CHANGE ORDER FORM

Change Order 3

Date of Issuance: 3/16/2020 Effective Date: 3/16/2020
 Owner: WSFC Utilities Owner's Contract No.:
 Contractor: D.H. Griffin Infrastructure Contractor's Project No.: 19-20-1310
 Engineer: HIGHFILL Infrastructure Engineering, P.C. Engineer's Project No.: WIN1702
 Project: Idols Rd Regional Lift Station Contract Name: Idols Rd. Regional Lift Station

Change Order for Installation of Power Conduits and Related Items
Idols Road Regional LS
February 11, 2020
HIGHFILL Project No. WIN1702

FIGURE A
NTS
1/24/2020

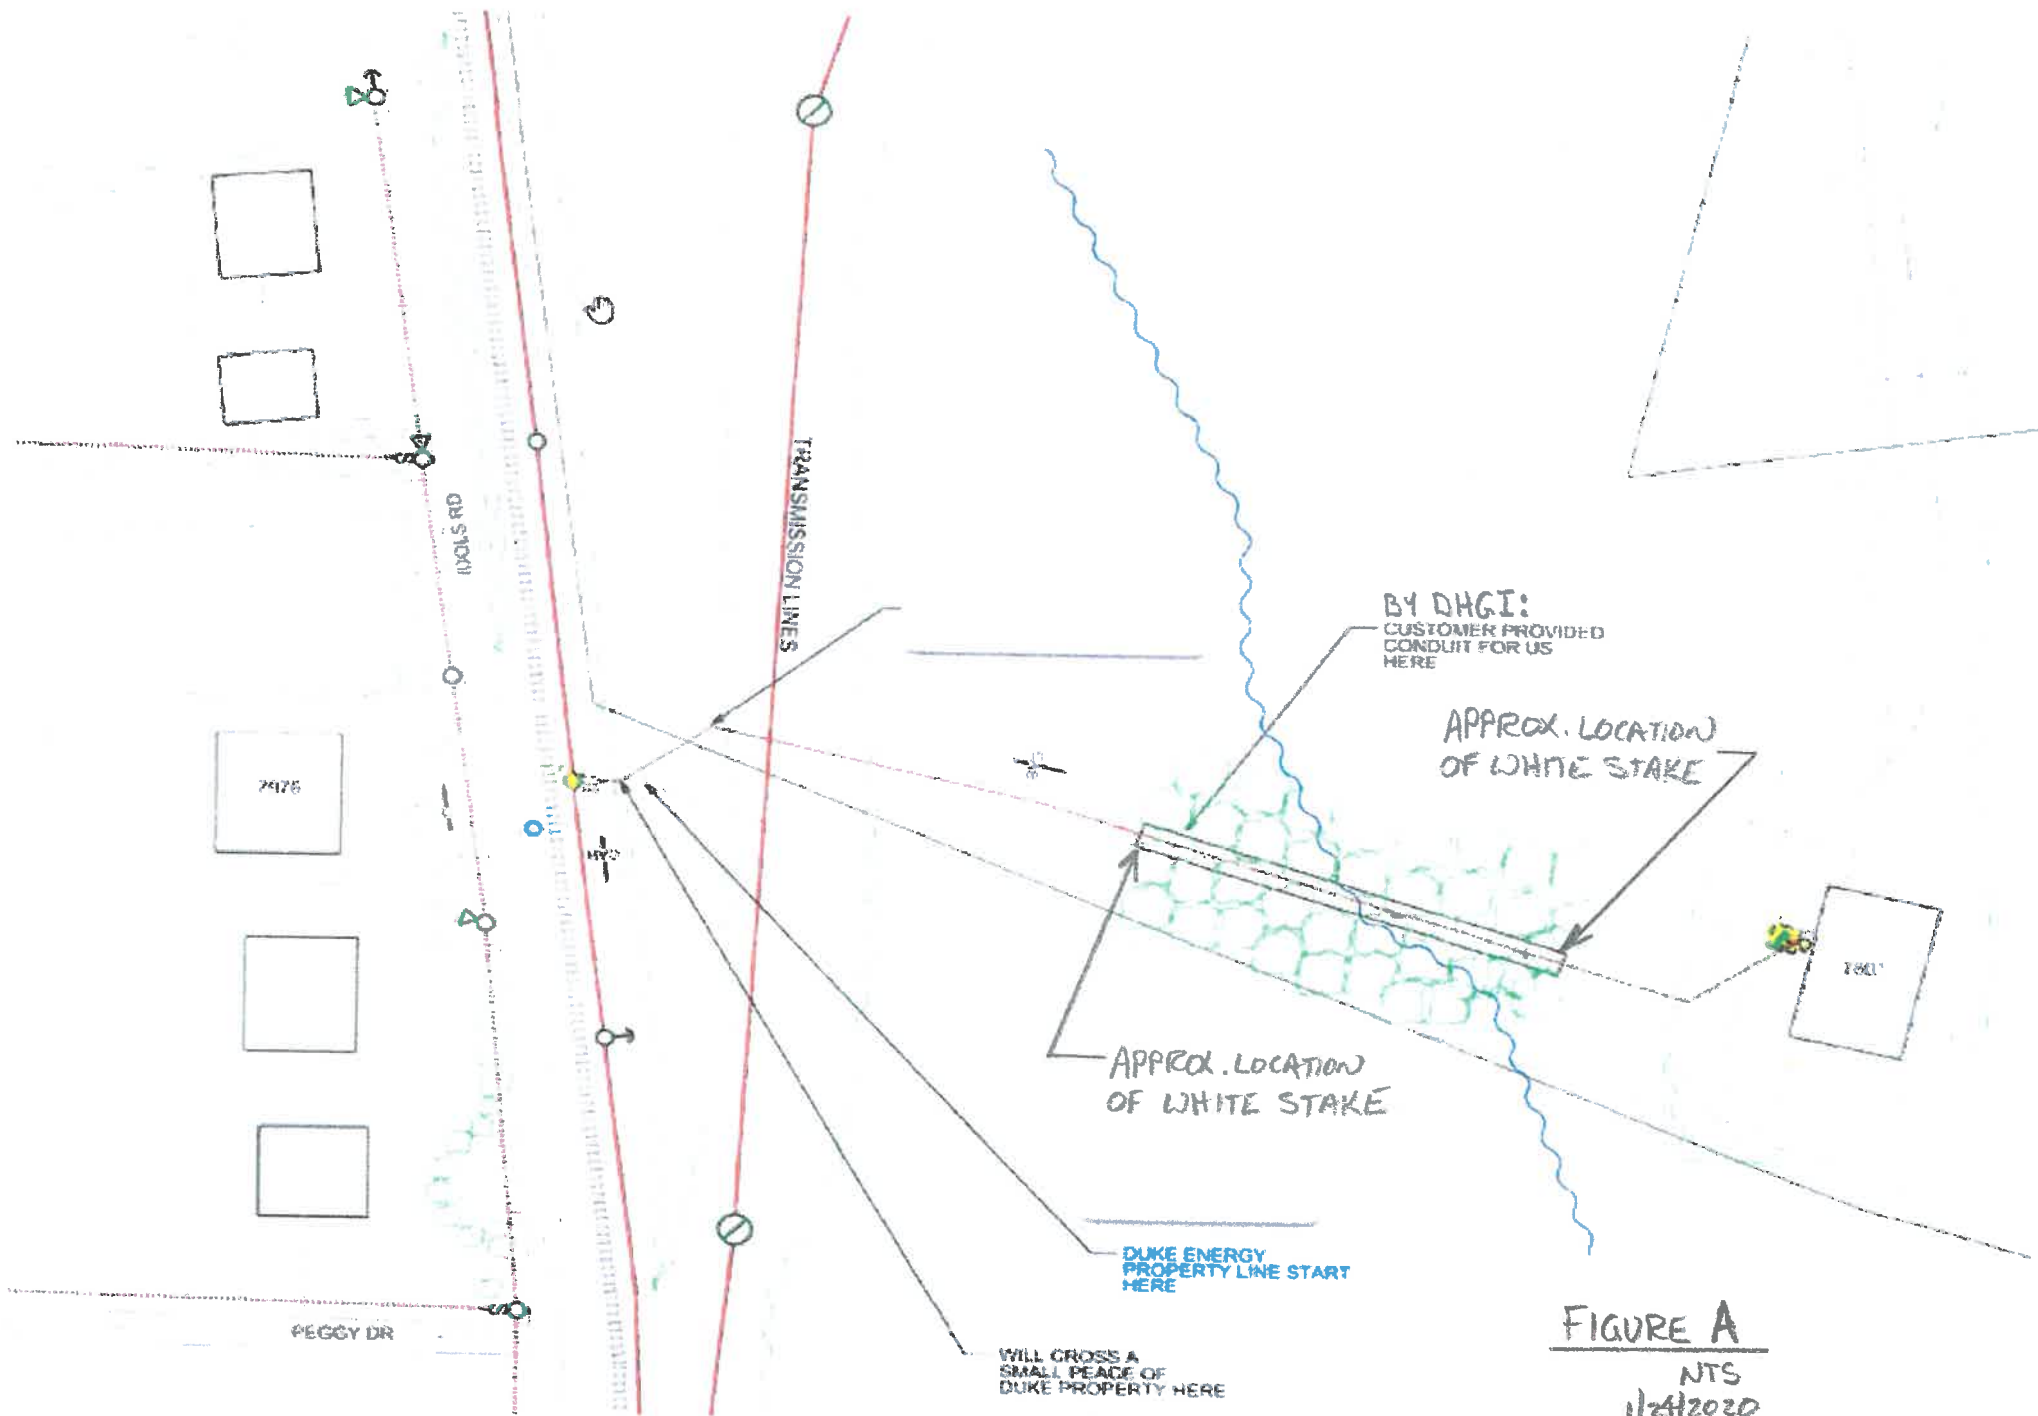
Install 2 runs of 4-inch diameter power conduit between the two white stakes annotated on Figure A, attached. The horizontal distance is 250 feet between the stakes. The conduits installed shall extend 10 feet beyond each stake (270 linear feet total) No conduit turns, horizontal nor vertical, shall exceed 45-degrees.

The ditch crossing is a regulated blue line stream; therefore, the installation shall be by Horizontal Directional Drill. Contractor has the option to drill the conduits individually or drill one larger conduit and install two 4" conduits inside the larger one. Leave each end of conduits sticking up 3-5 feet above grade to identify the location for Duke Power's connection to their installation.

Entry and exit angles shall allow for connection of conduits by Duke Power's open cut trenches at a depth of 36" to 48" of cover. Contractor shall design the HDD pipe wall thickness for depth of installation, HDD operations including pipe pull-back and fusing design. The drilled pipe shall be HDPE or fusible PVC. The drill path shall be a straight line between the stakes to remain within the Duke Power easement.

FIGURE B

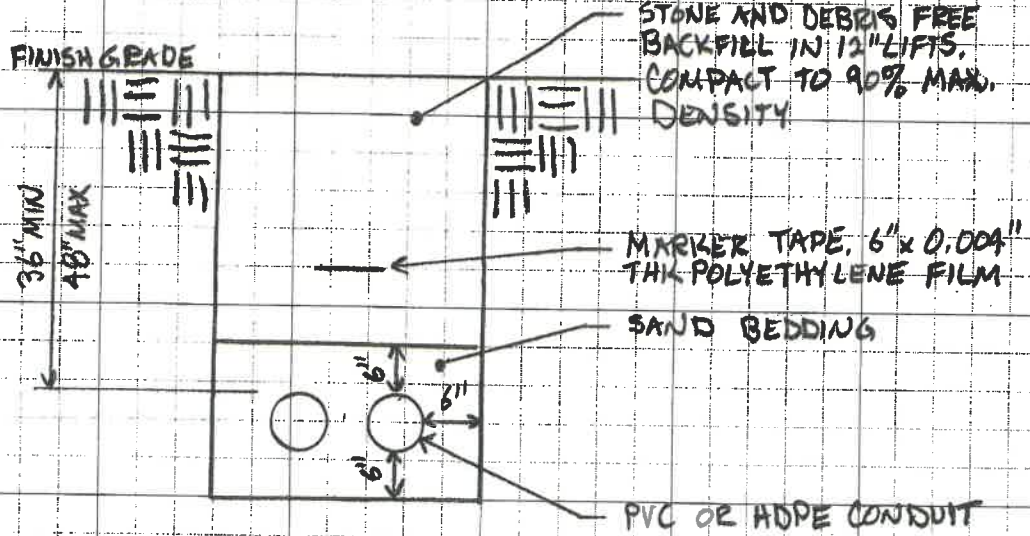
- As it pertains to installation depth [by open cut], the conduit shall be a minimum of **36 inches** deep (measured from grade to top of conduit) to a maximum of **48 inches** deep along all sections of the installation. The depth of the conduit installation where the conduit will physically reside underneath the stream bed will also need to comply with the minimum/maximum stated earlier.

FIGURE D
1/24/2020

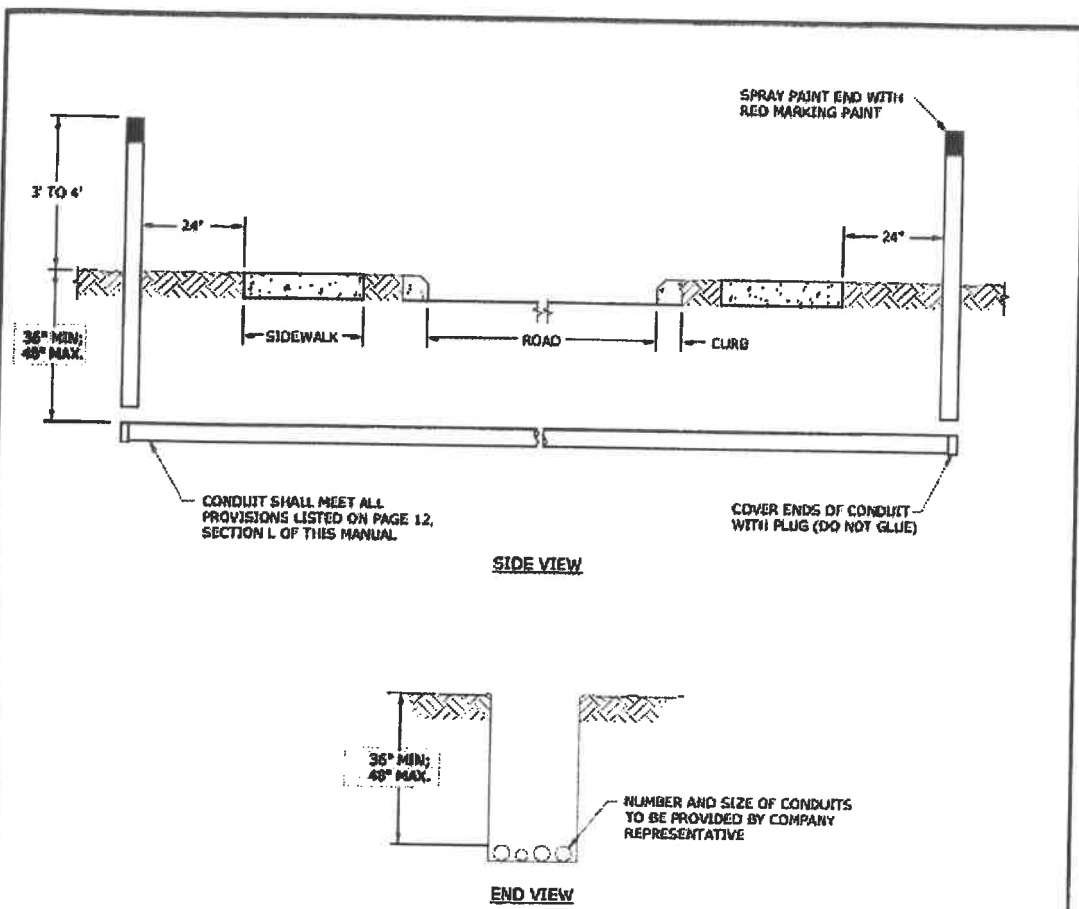
- The “*ConduitCrossing-SvcReqmtManual*” document is a visual reference for the conduit installation, regardless of the obstacle being crossed in most cases. The primary take away from this document are the specifics surrounding the **conduit marking, pull string, end encapsulation, and minimum depths**. [Figure D, attached]
